### TECHNICAL BULLETIN

[Issue No.] T06-0004
 [Page] 1/3

[Title] Changes in specifications of duplex remote master function for MELSECNET/10 remote I/O network.
 [Date of Issue] Oct. 1, '98

[Relevant Models] AJ71QLP21, AJ71QLP21S, AJ71QBR11, A1SJ71QLP21, A1SJ71QLP21S, A1SJ71QBR11, AJ71QLP21G
 A1SJ71QLP21S, A1SJ71QBR11, AJ71QLP21G

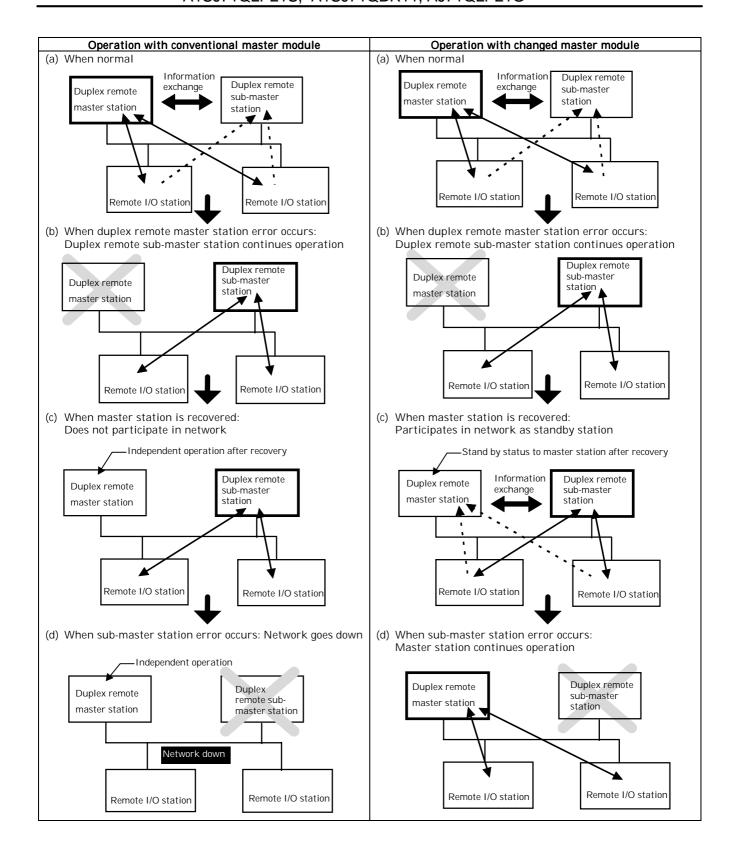
With the conventional MELSECNET/10 remote I/O net's duplex remote master function, the following types of operations were taken after the remote master station went down.

- (1) The remote sub-master station continued to run the network.
- (2) Even if the remote master station was normally recovered, it did not participate in the network.
- (3) When the remote sub-master station went down, <u>the network went down</u> because there was no remote master station.

With the changed duplex remote master function, the following operations take place after the remote master station goes down.

- (1) The remote sub-master station continues to run the network.
- (2) When the remote master station is normally recovered, <u>it participates in the network in the standby status to the master station.</u>
- (3) If the remote sub-master station goes down, the remote master station in the standby status to the master station <u>continues to run the network.</u>
